Handbook of Human Reliability Analysis with Emphasis on Nuclear Power Plant Applications

Addendum #1 to NUREG/CR-1278, August 1983

Following are some corrections to the above document, listing the page (p) and paragraph (para) numbers. Understandable typos are excluded. Some updating of references is included.

Figure 12-3 Initial-screening model of estimated HEPs and UCBs for diagnosis within time T of one abnormal event by control room personnel (based on Oswald et al, 1982).

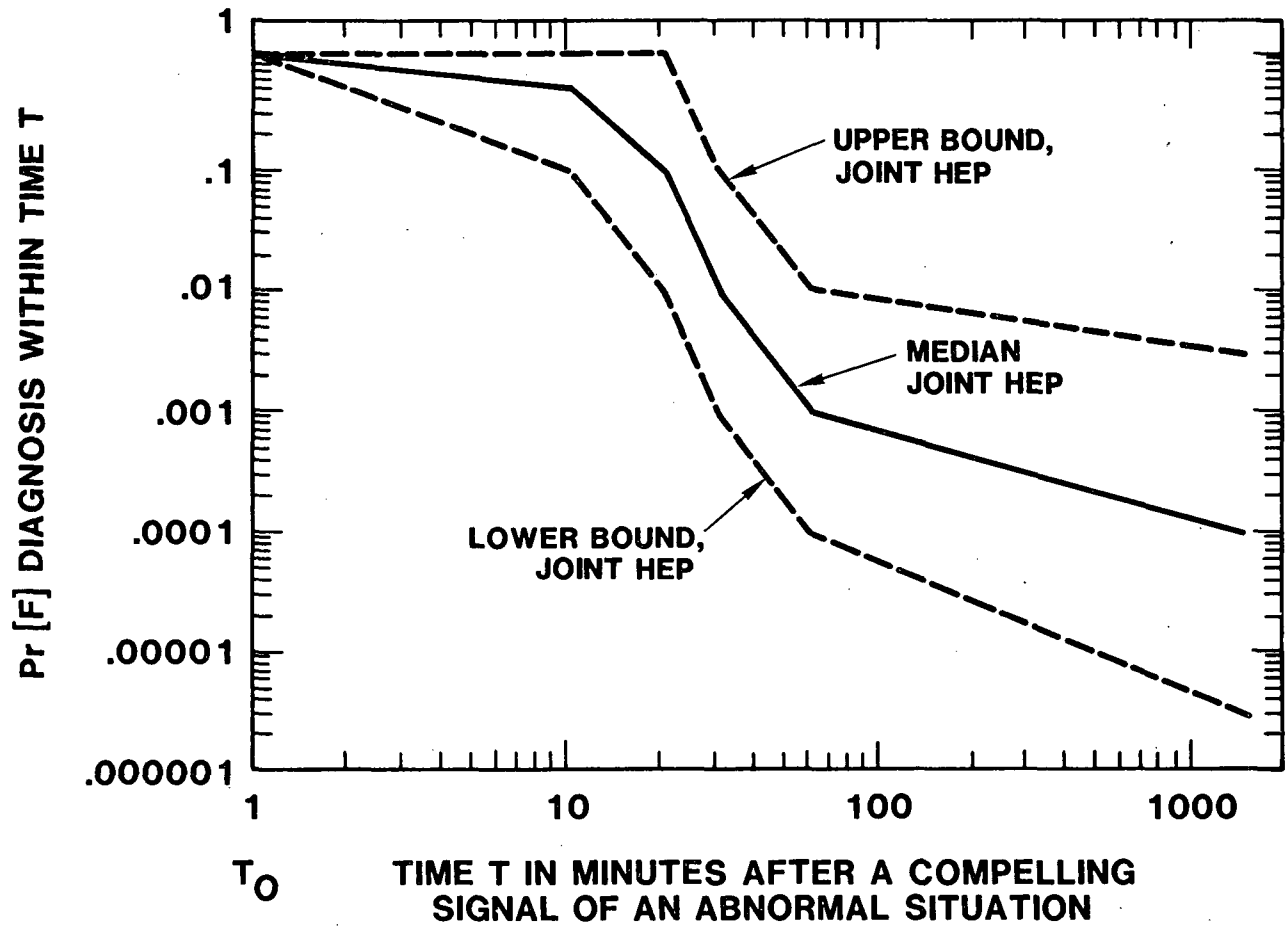
- 12-8,4 Line 7: ... emergency operating procedures ...
- 12-12,3 Line 4 & 5: ... Wreathall (1981, p 104, and 1982), ...
- 12-13 Table 12-3: The 3 lines in the figure should meet at the 1.0 $\text{Pr}[F]$ rather than at the .9 HEP. Also, the 1 (e.g., HEP of 1.0) is incorrectly placed; it should be in the same relative position above the .9 HEP as is the .1 HEP above the .09 HEP. The $\text{Pr}[F]$ values for the lower bound and median HEPs at 10 minutes are correct. The $\text{Pr}[F]$ values for the upper bound HEP at 20 minutes should be 1.0.

Figure 12-4 Nominal model of estimated HEPs and UCBs for diagnosis within time T of one abnormal event by control room personnel.

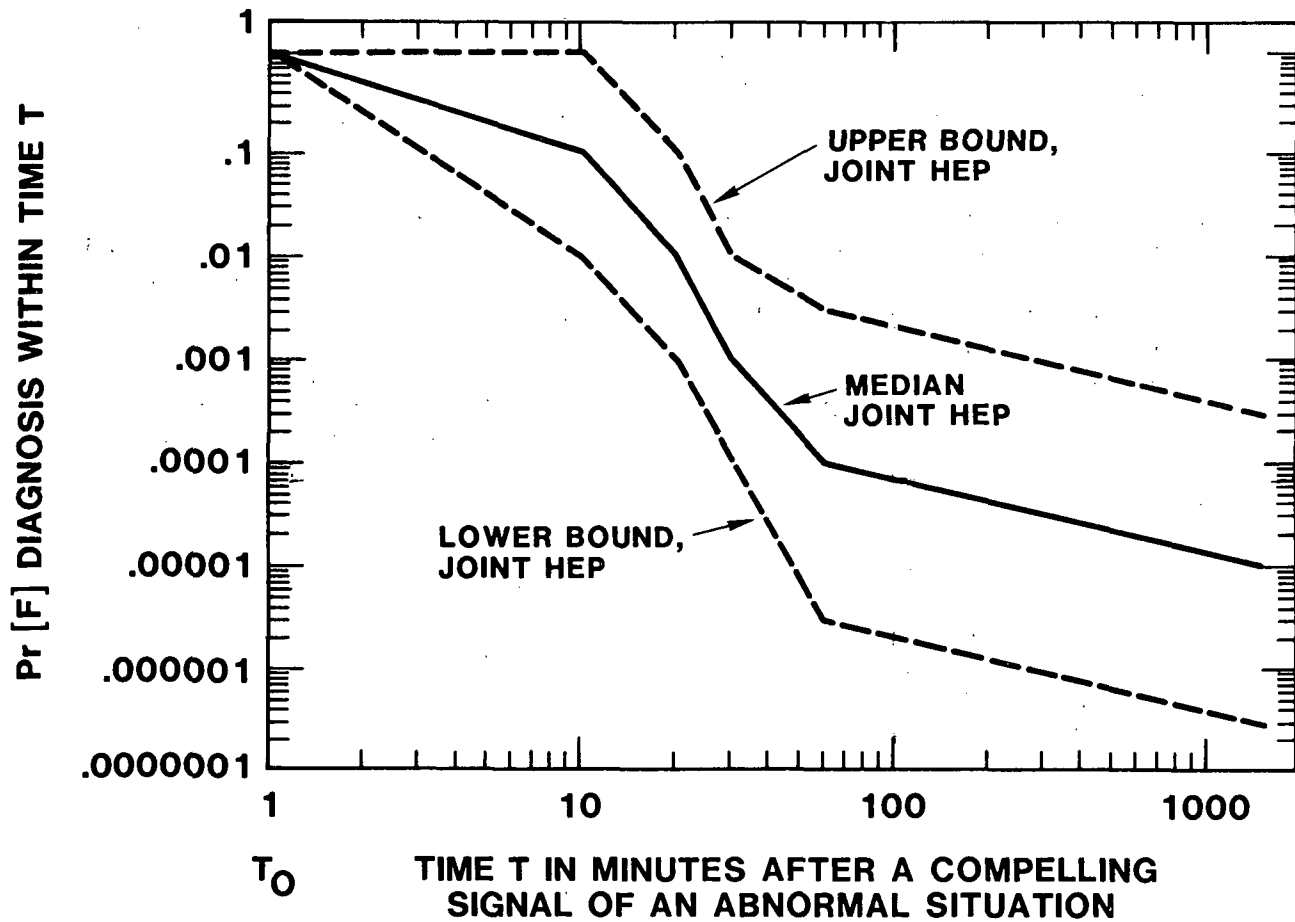
- 12-20 Table 12-4: The 3 lines in the figure should meet at the 1.0 Pr[F] rather than at the .9 HEP. Also, the 1 (e.g., HEP of 1.0) is incorrectly placed; it should be in the same relative position above the .9 HEP as is the .1 HEP above the .09 HEP. The Pr[F] values for the lower bound and median HEPs at 10 minutes are correct. The Pr[F] values for the upper bound HEP at 10 minutes should be 1.0.

Figure 20-1 Search scheme for use of Chapter 20 tables (p 1 of 3).

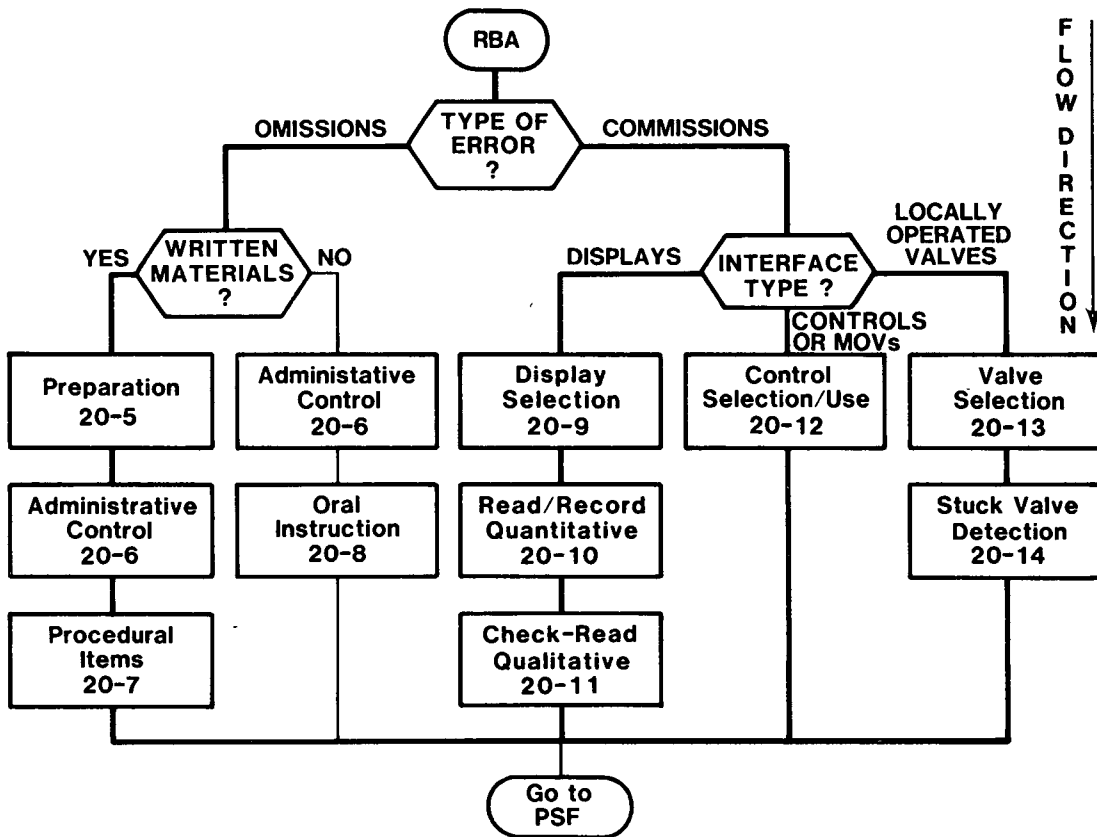
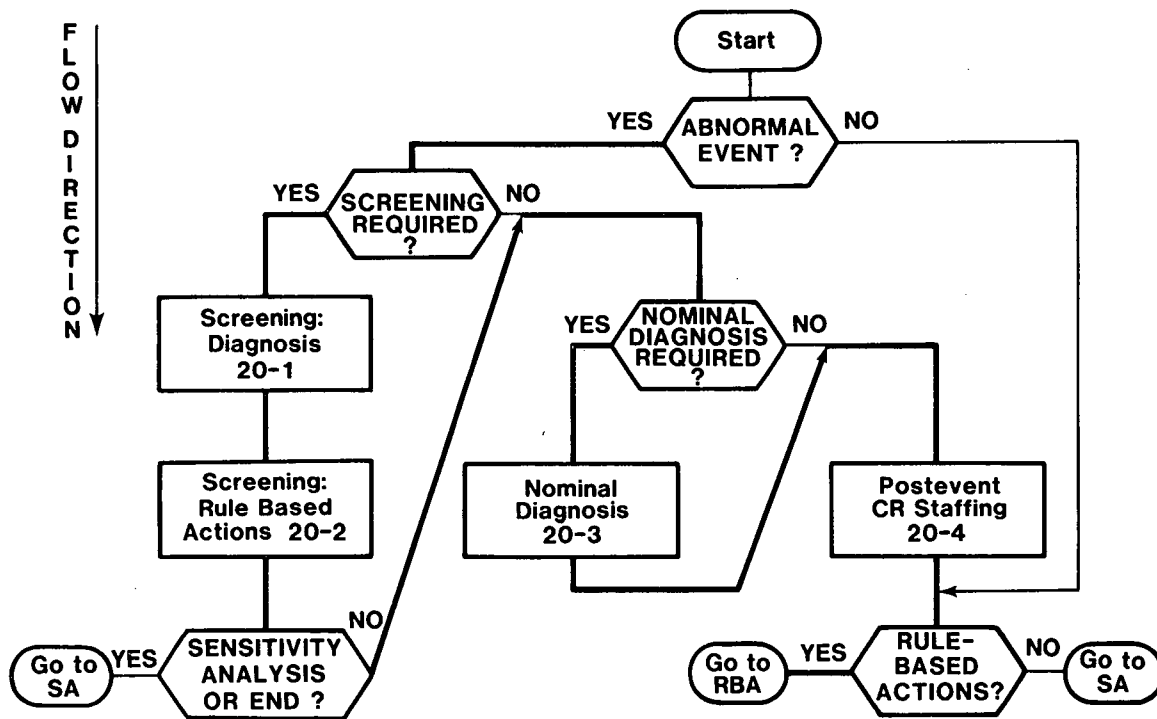
- 20-3 Figure 20-1 (p1 of 3): Insert a "Screening Required?" hexagon in the No line following the "Abnormal Event?" hexagon. The YES and NO lines from the new hexagon go to the "Rule-Based Actions?" hexagon. Insert a "Decide on Screening Rules" box in the YES line.
[This change is necessary because many PRAs require some form of screening for pre-accident situations.]

Figure 20-1 Search scheme for use of Chapter 20 tables (p 2 of 3).

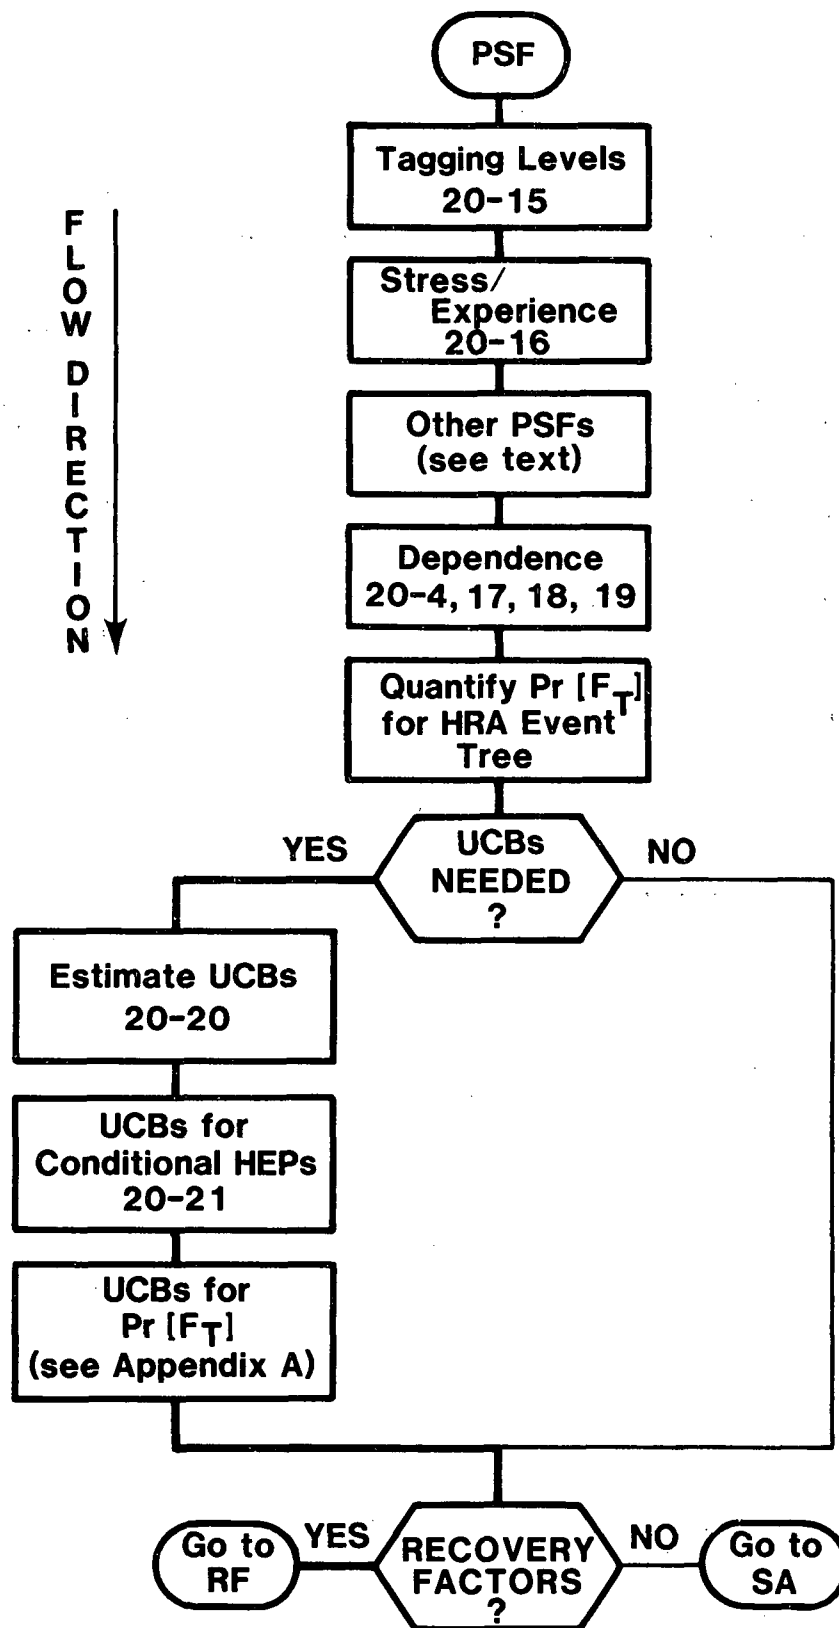
- 20-4 Figure 20-1 (p2 of 3), "Other PSFs" box: Other PSFs (see text, especially pp 3-14, -17,- 19,- 72, and 17-7)
- 20-6,5 Item (2), line 7: ... Assume YES. (Note: Screening may also be required for non-abnormal tasks, as shown in the NO path following the ABNORMAL EVENT? hexagon.)
